July 14, 1978

Docket No. 50-335

Enclosed is a replacement for Figure 3.1-2 of the Technical Specifications issued as a part of Amendment No. 27 to Operating License DPR-67 for St. Lucie Unit No. 1 on May 26, 1978.

Figure 3.1-2 CEA Insertion Limits vs THERMAL POWER with 4 Reactor Coolant Pumps Operating

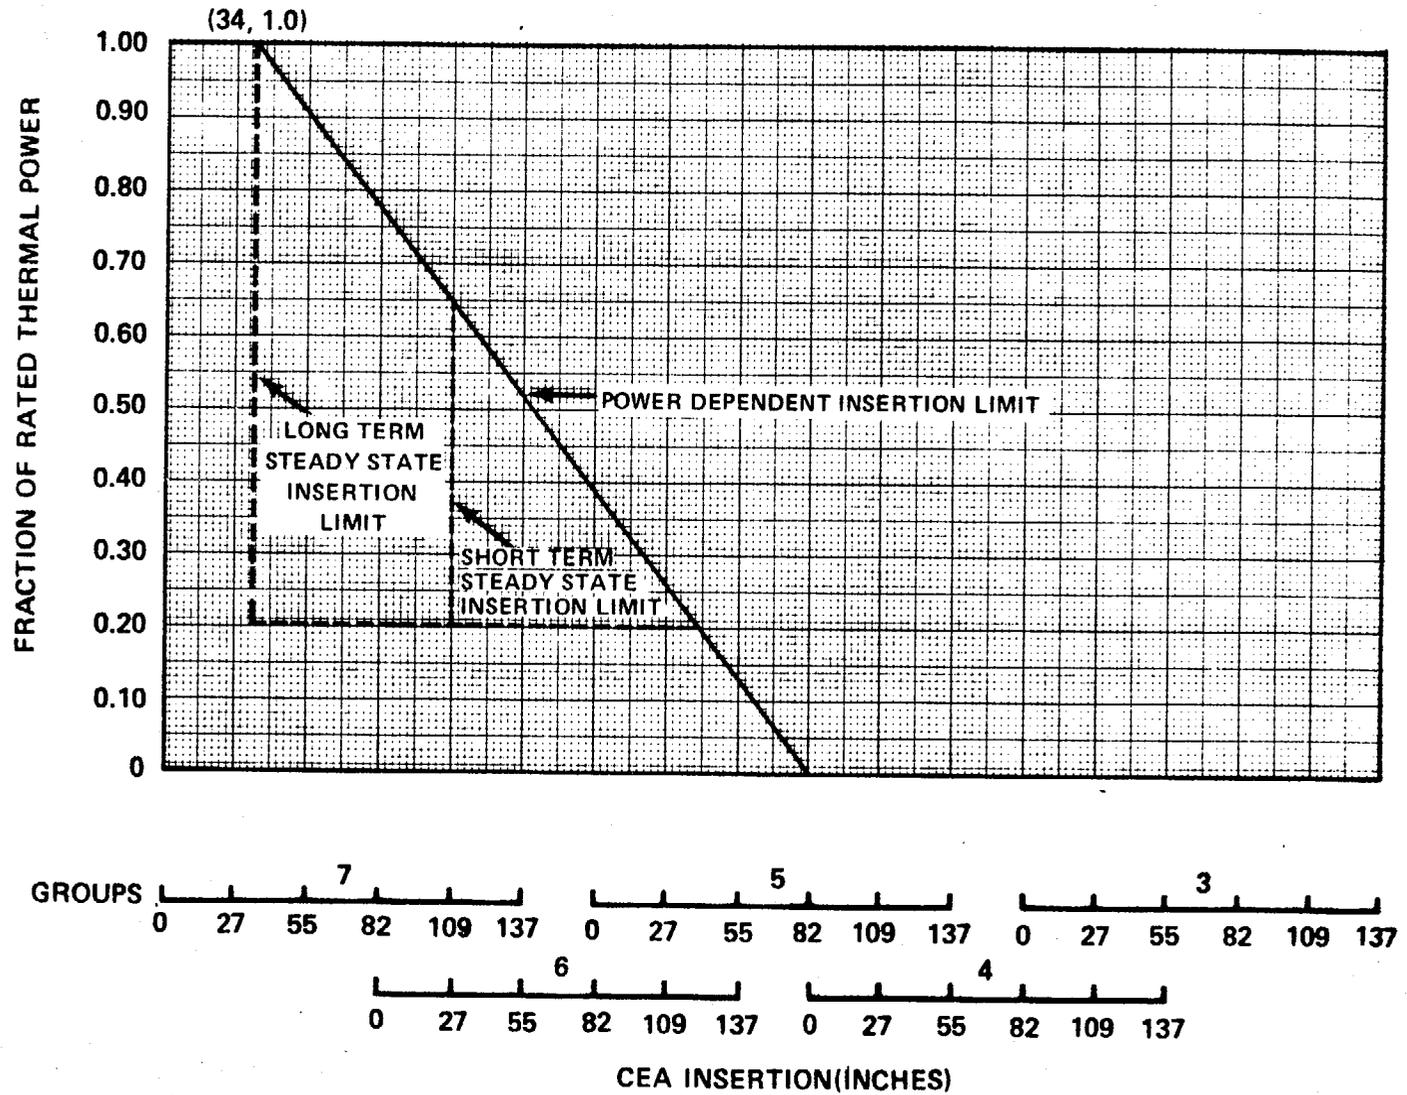
The replacement of the Power Dependent Insertion Limit (PDIL) figure is in response to your letter dated June 28, 1978. In this letter you state that the abscissa of Figure 3.1-2 was not changed when your staff converted the CEA insertion PDIL from percent to inches. This resulted in a coordinate mistake in the upper left corner of the figure where (25, 1.0) was used instead of the correct value of (34, 1.0).

We have determined the conclusions reached in our Safety Evaluation for Amendment No. 27 are not changed by correcting Technical Specification Figure 3.1-2.
